DESIGN STATEMENT

FOR THE PROPOSED DESIGN CHANGES AT ALSTON HOUSE/LAND TO THE NORTH OF BEECH HOUSE, ALSTON, PRESTON, LANCASHIRE.

Job No. 5335

Version: 1.1 | JULY 2025

PL02: Proposed Site Plan (Not to scale).

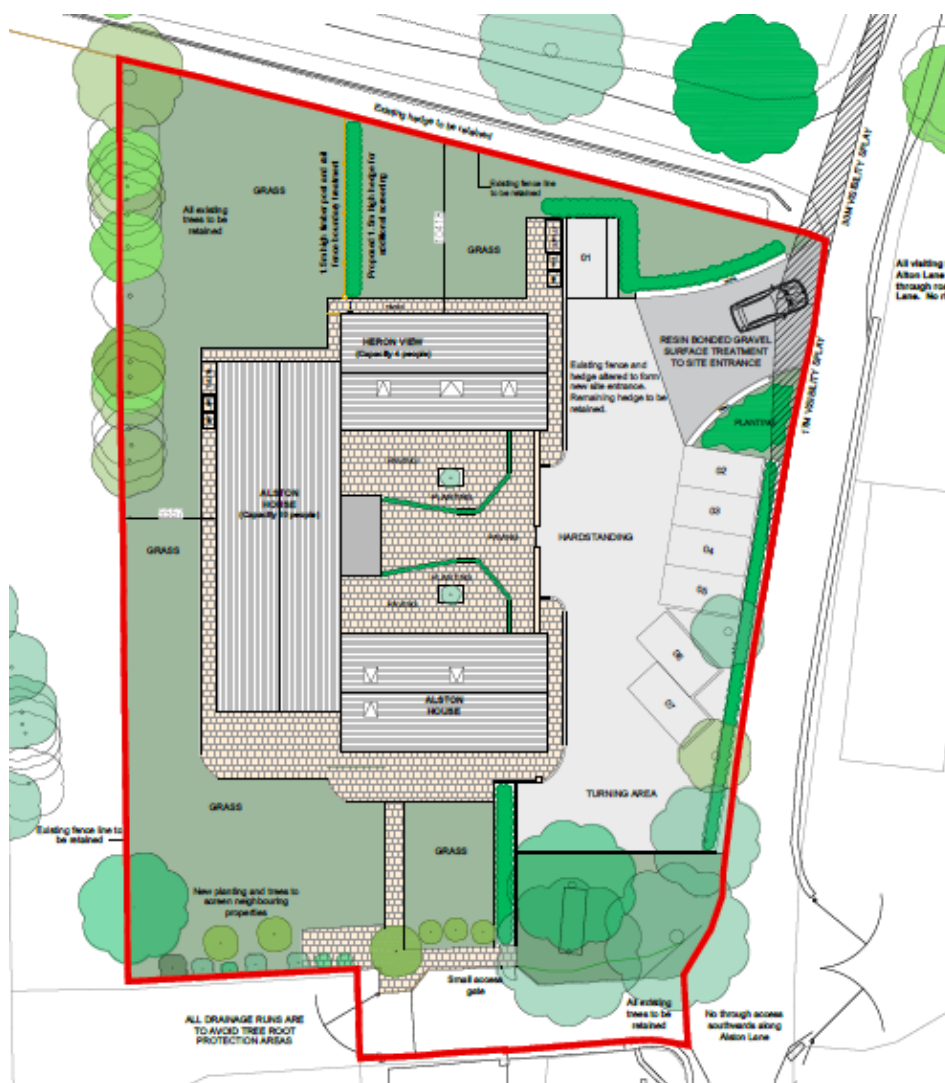
The changes to the internal floorspace have reduced the number of bedrooms which is more acceptable for a small-scale holiday let. The reduction in rooflights and removal of windows is more acceptable as this reduces the visual prominence of the building. The level of parking is considered to be acceptable, to include 7 no. spaces for 7 no. bedrooms as per the approved scheme and the additional planting and retention of the hedge along the front boundary are considered an improvement from the previously refused scheme.

Whilst the roof height and pitch would remain the same as the refused scheme, the amendments proposed help lessen the visual impact of the scheme when viewed from the road and from the Public Bridleway.

In addition to changes in fenestration, enhancements have been made to the site's landscaping and boundary treatments. The revised scheme includes new planting and the retention and improvement of the existing hedgerow along the front boundary, softening the development's interface with the public realm. The car parking layout has also been revised to provide seven dedicated spaces, aligning with the seven bedrooms now proposed across two holiday units. This represents a significant reduction in unit density and internal capacity compared to the originally approved scheme, supporting the Council's preference for lower-scale tourism development in rural areas.

PL03: Proposed Front and Side Elevations (Not to scale).

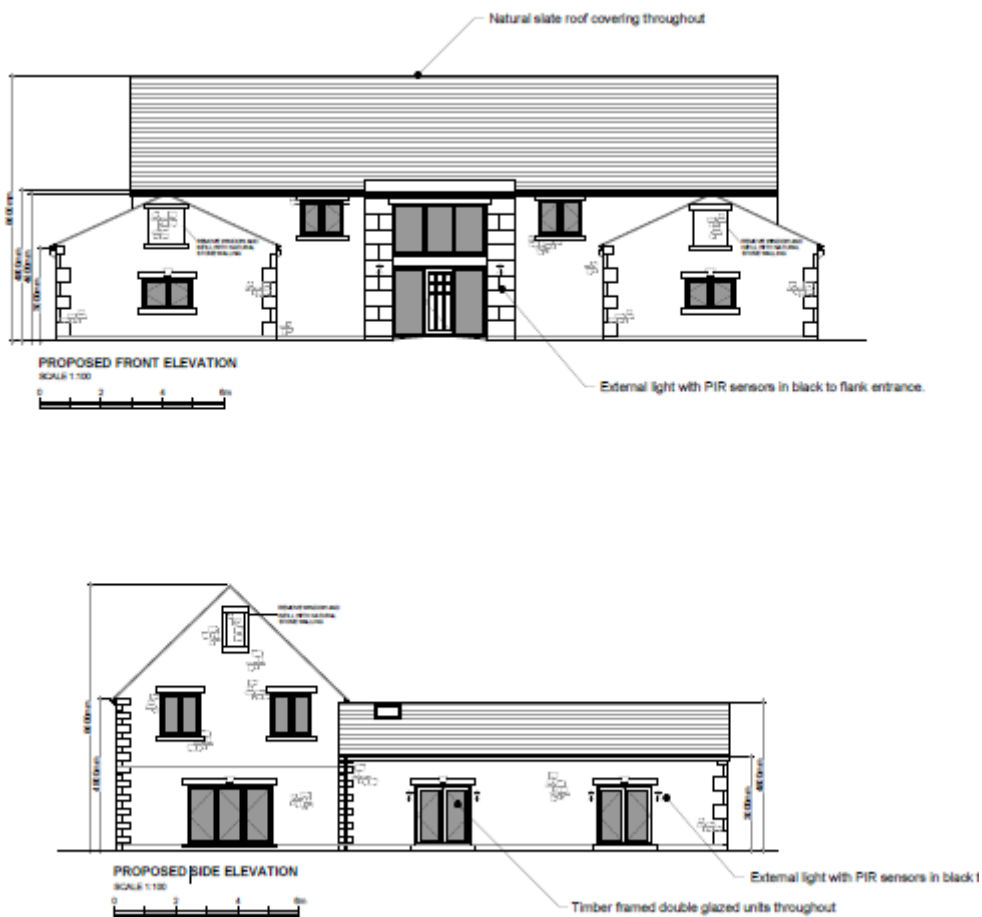
“The amended plans are an improvement from the previously submitted pre-application drawings. They include the removal of the 2nd floor windows, removal of all rooflights from the main roof, infilling of first floor windows to the front elevation outriggers and the retention of the internal roof slope rooflights with the addition of one rooflight to the outside roof slope to the lower-level outrigger. In addition, the number and location of external lighting does not significantly differ from the approved scheme.”

In direct response to both the feedback from that refusal and subsequent detailed pre-application advice from the Council, the applicant has made a series of positive and sensitive revisions to the scheme. These changes are now in the process of being implemented on site. Key alterations include the removal of all second-floor windows and rooflights on the main roof slope, reducing the visual prominence of the building from both public and private viewpoints. First-floor windows within the projecting outriggers have also been removed, and only one new rooflight has been introduced—strategically located on the external slope of the lower-level outrigger roof, with retained rooflights positioned discreetly on internal courtyard facing slopes where they are largely concealed from view.
